**M25 JUNCTION 10 / A3
WISLEY INTERCHANGE IMPROVEMENT
DEVELOPMENT CONSENT ORDER (DCO)
APPLICATION**

**WRITTEN REPRESENTATION BY
MIKE HIBBERT (MSc MCIT MIHT MILT MIO D DipEng)
VOLUME 1 of 2 – TEXT
(RHS/MH/1)**

TTHC Ref: MH/M16114-02B
Date: November 2019

Figure 2 – Ockham Park junction – South facing slip roads

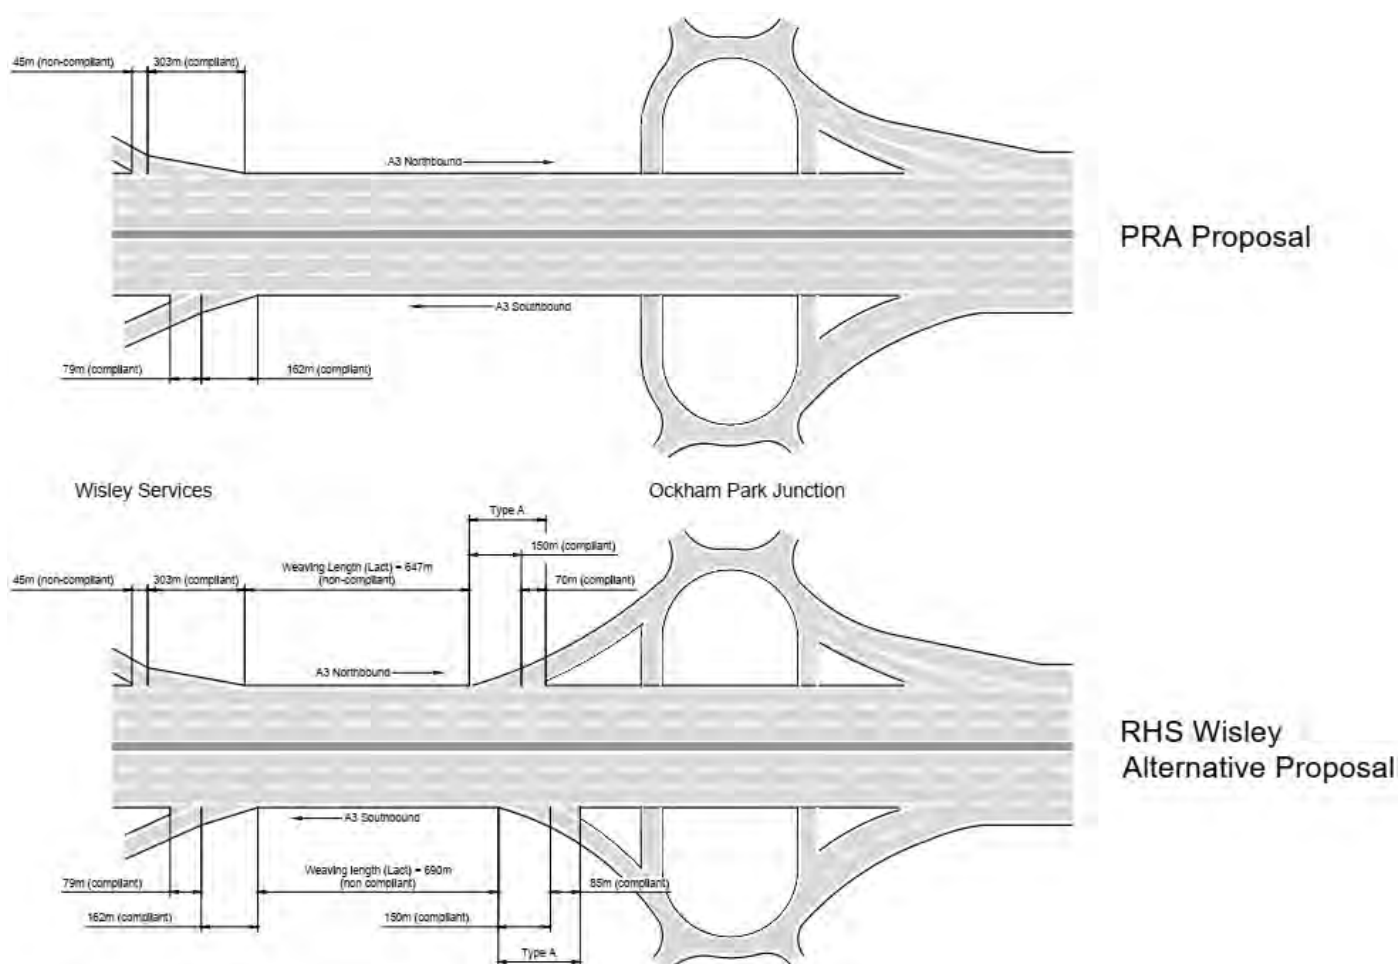
4.1.6. Highways England acknowledge the proposals from RHS for south-facing slip roads at Ockham Park junction (Figure 2) and recognise that they could, if feasible and affordable, provide more direct access to Wisley Lane and RHS Garden Wisley, to and from the A3 south. However, the feasibility of delivering the south facing slip roads has a number of localised and much wider challenges that would have to be overcome:

- The provision of slip roads at junctions along this section of A3 between Guildford and the M25 is typically that face one direction only. The impacts of adding slip roads to the other side of a junction could have wider impacts on surrounding roads and villages.

APPENDIX C
Signage Scheme Comparison

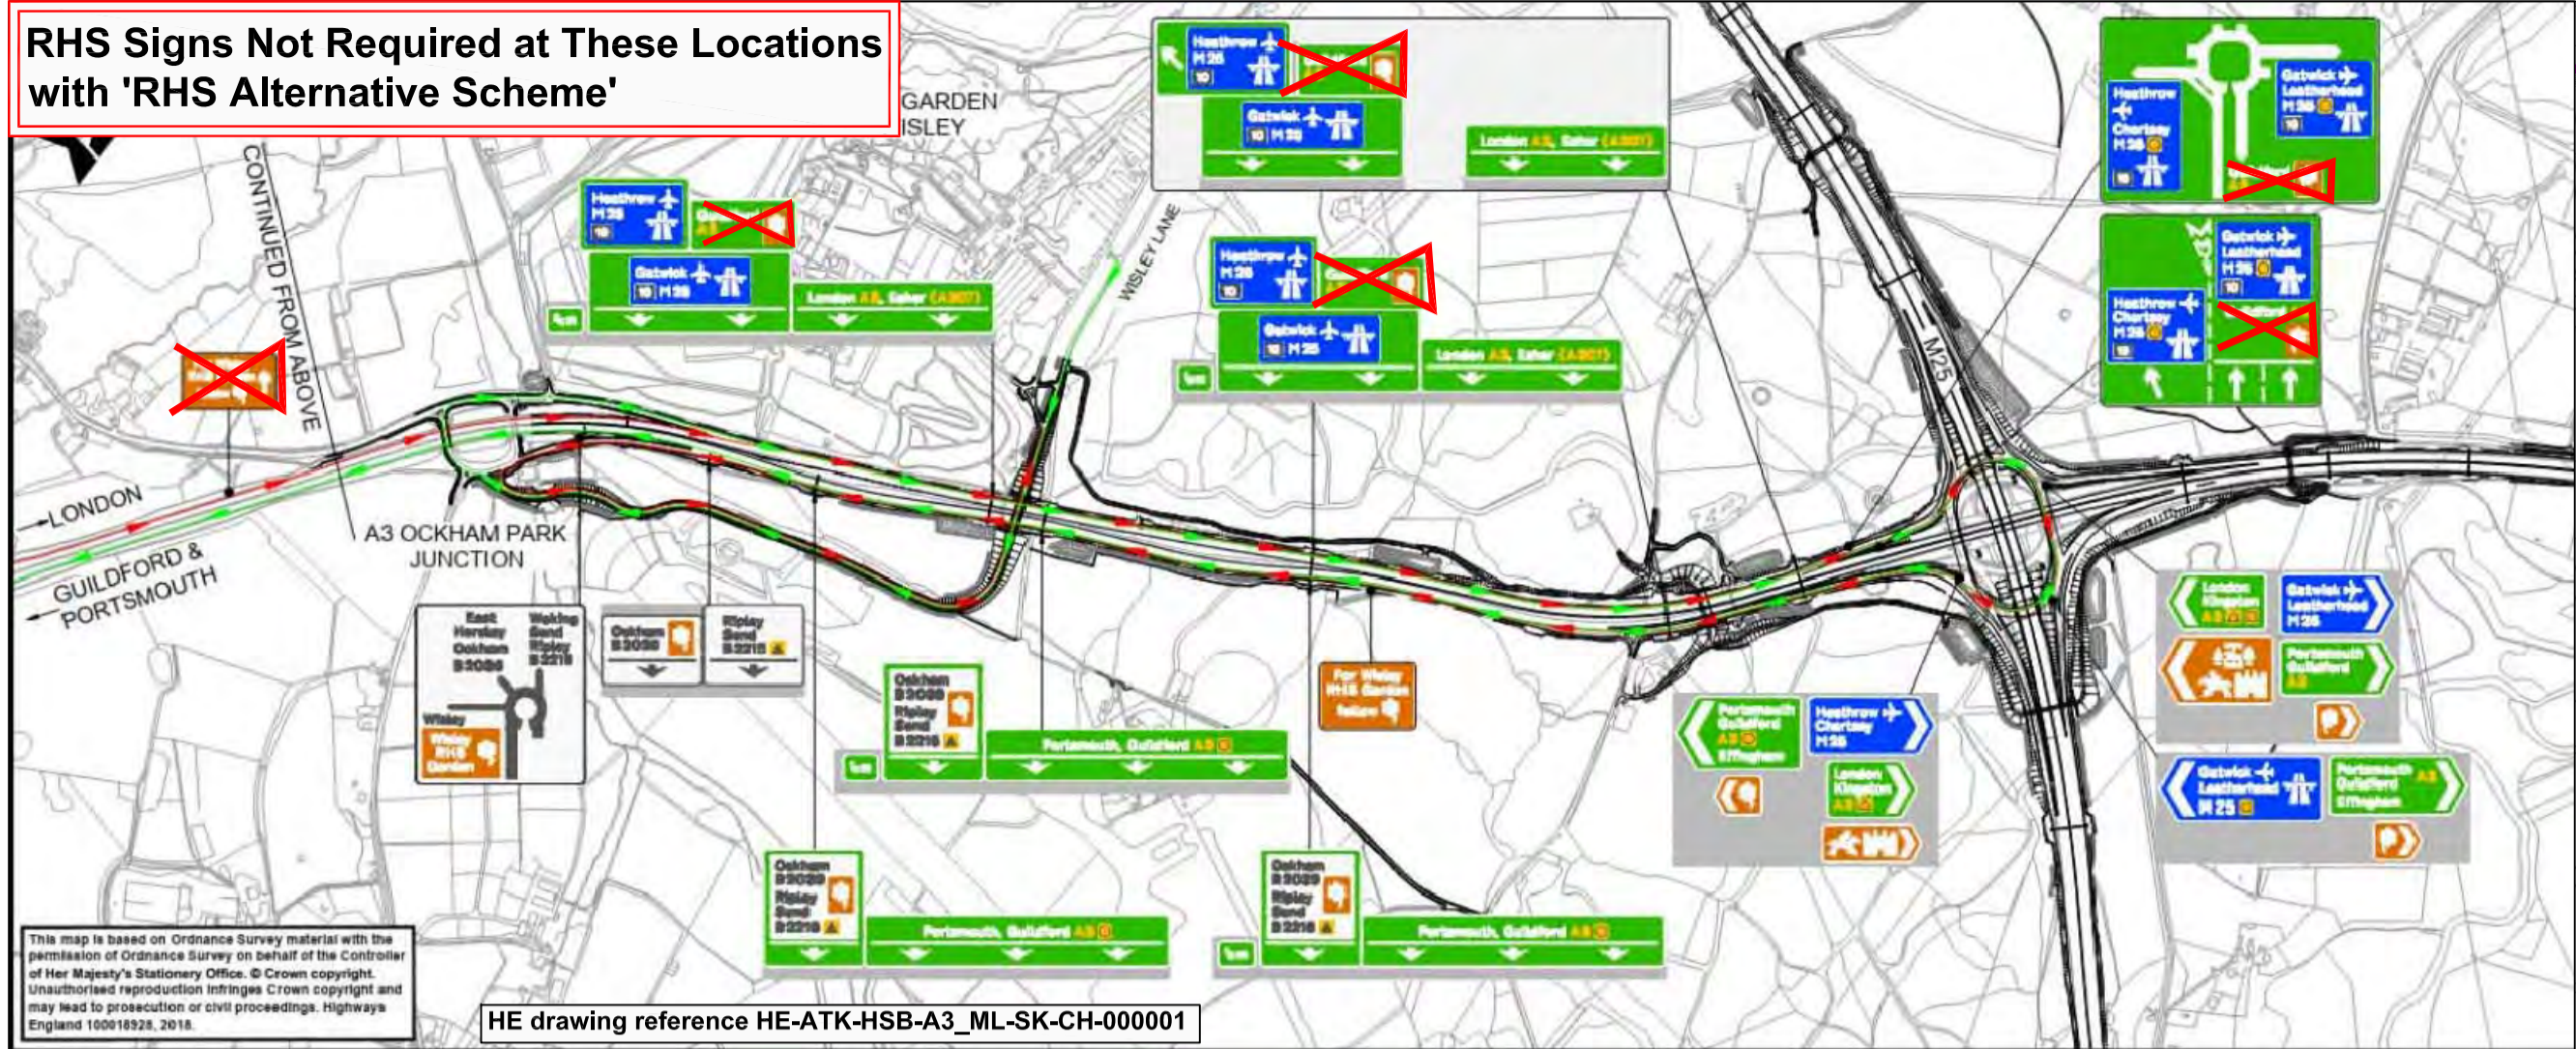
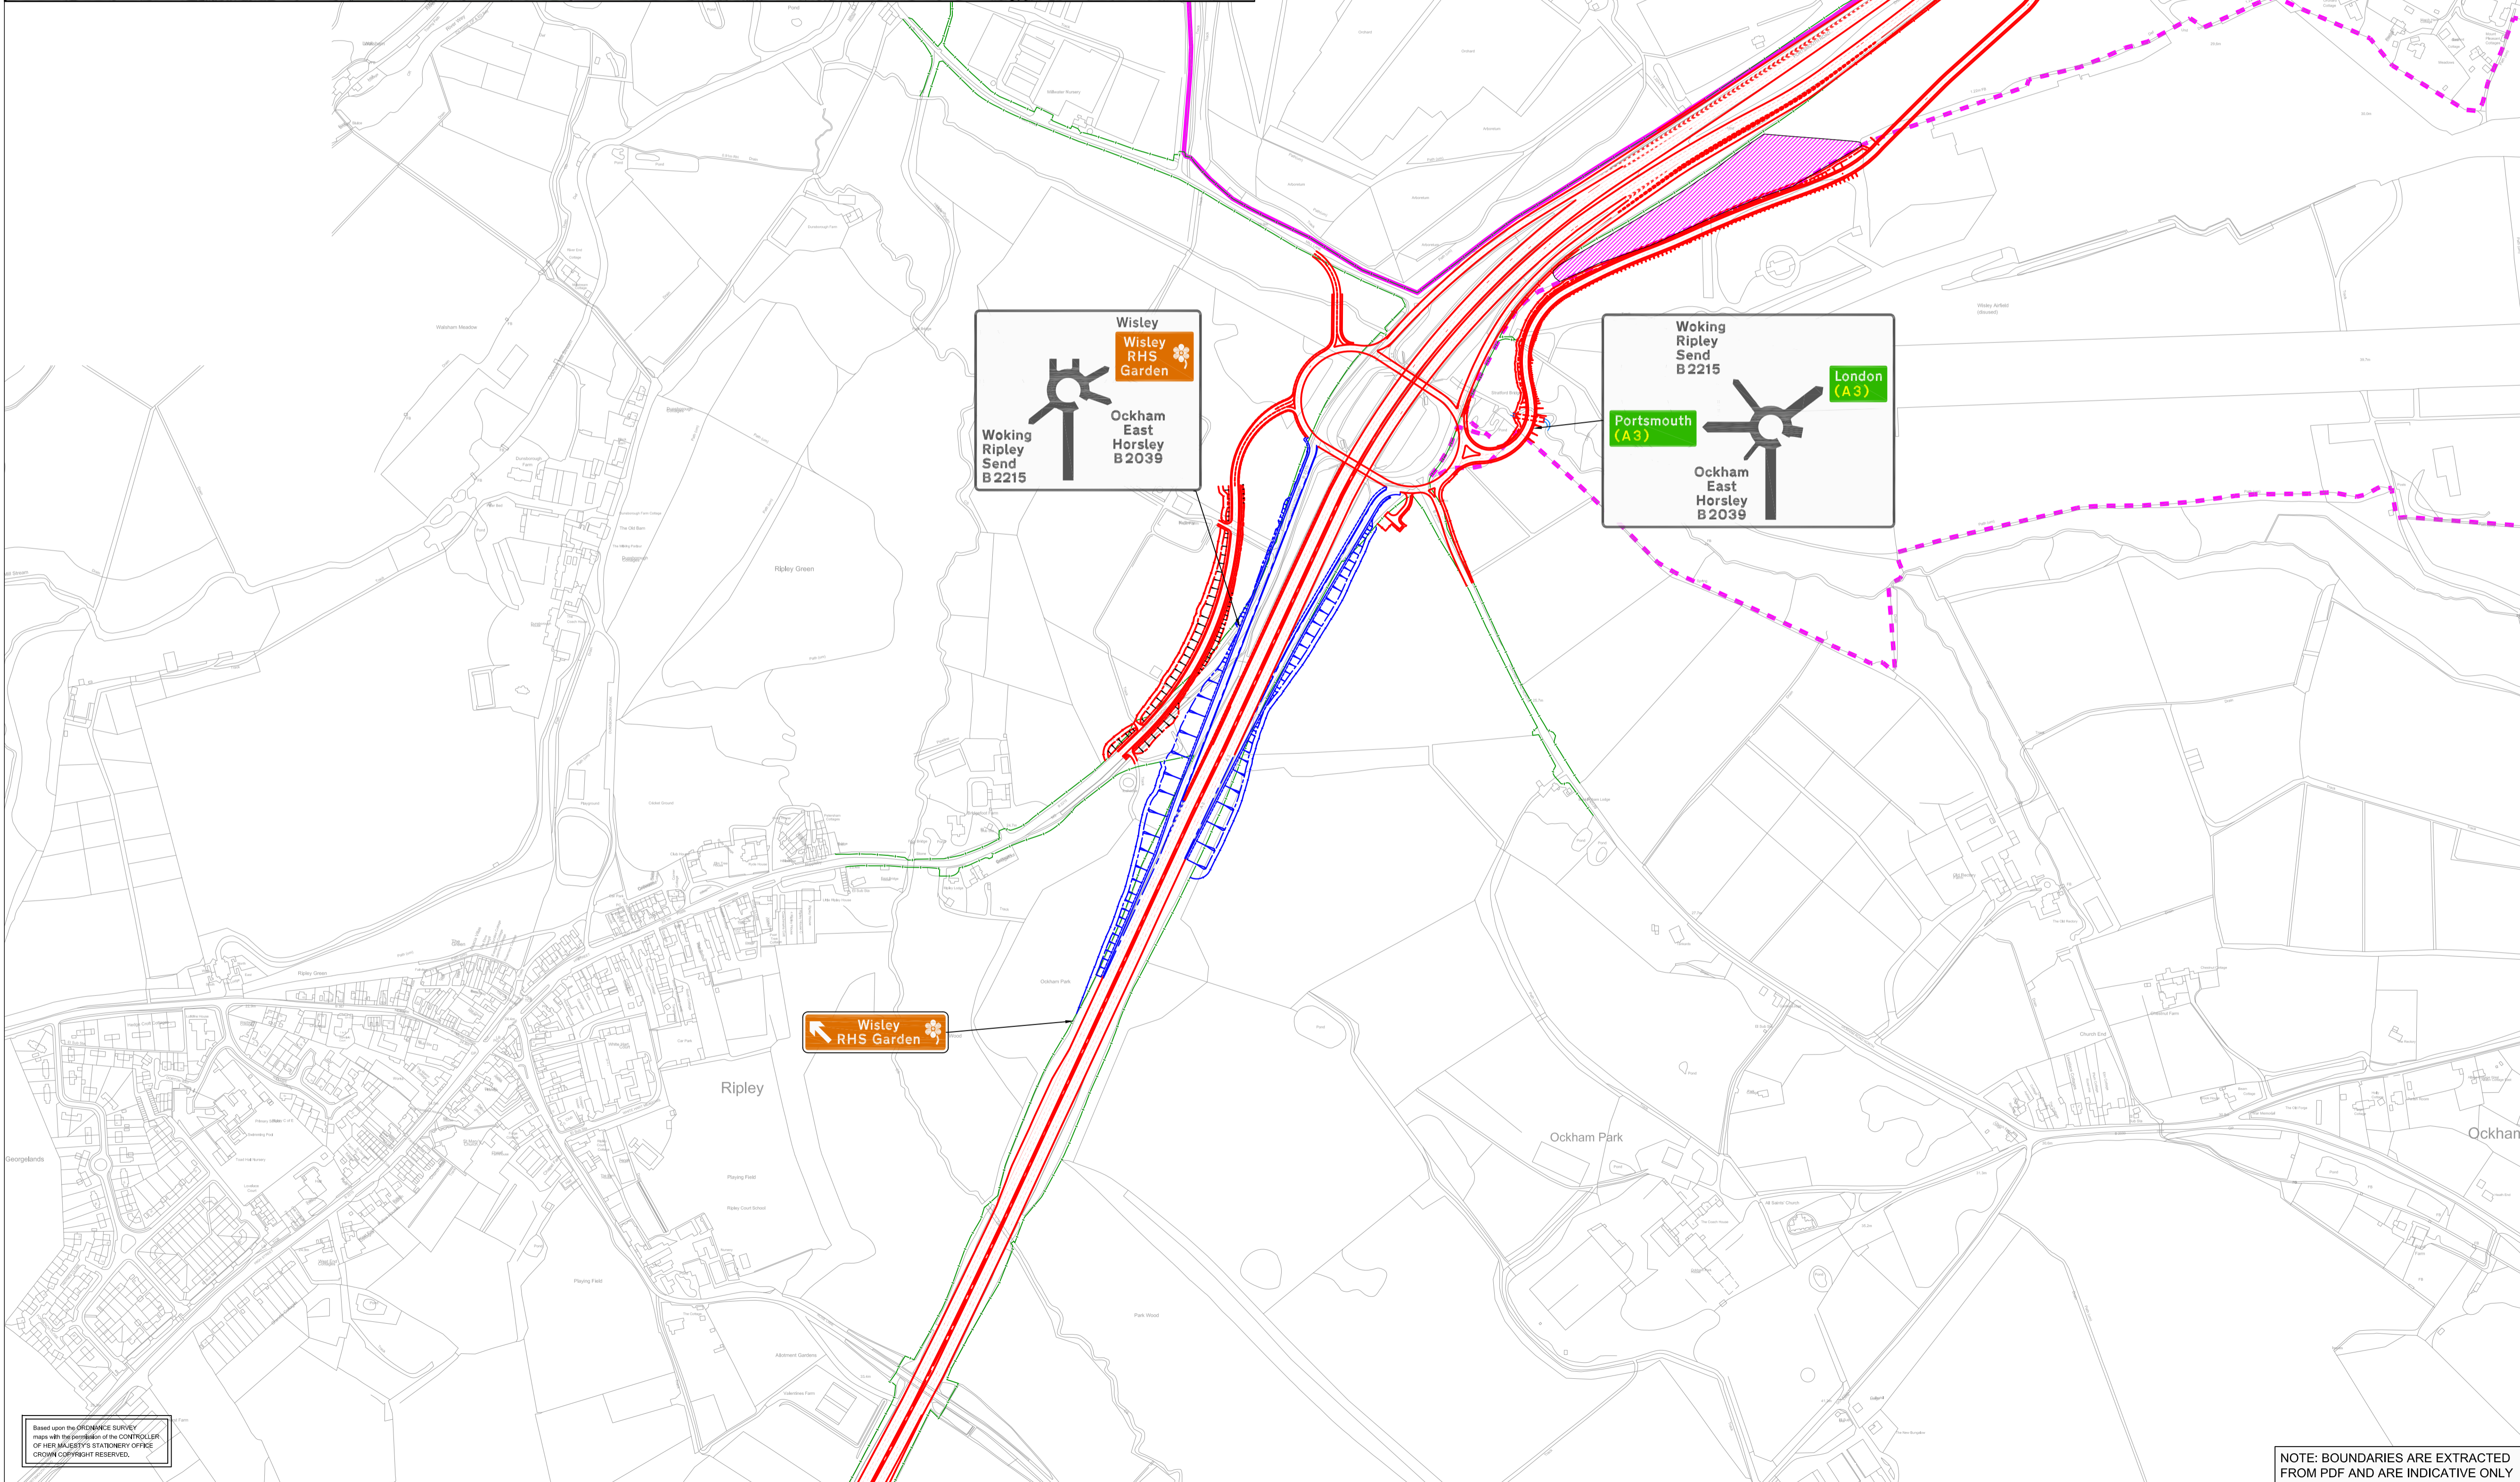
- 4.17 The proposed signage scheme itself is provided in Appendix C of the September 2019 Technical Note. As shown on the first drawing within Appendix C, if travelling from the south the HE scheme proposes a total of 12 'RHS' Brown signs to direct visitors to the Garden.

- 4.18 By design, the DCO Scheme requires these multiple new 'u-turning' movements for trips to and from the south to be undertaken. As a consequence of the need to pass the Garden up to three times, via two u-turns (at both J10 and at the Ockham Roundabout), I believe that the signed route will result in driver uncertainty, confusion and stress, with drivers questioning the logic of passing the Garden and u-turning more than once. In this regard the DCO Scheme

RHS Signs Not Required at These Locations with 'RHS Alternative Scheme'
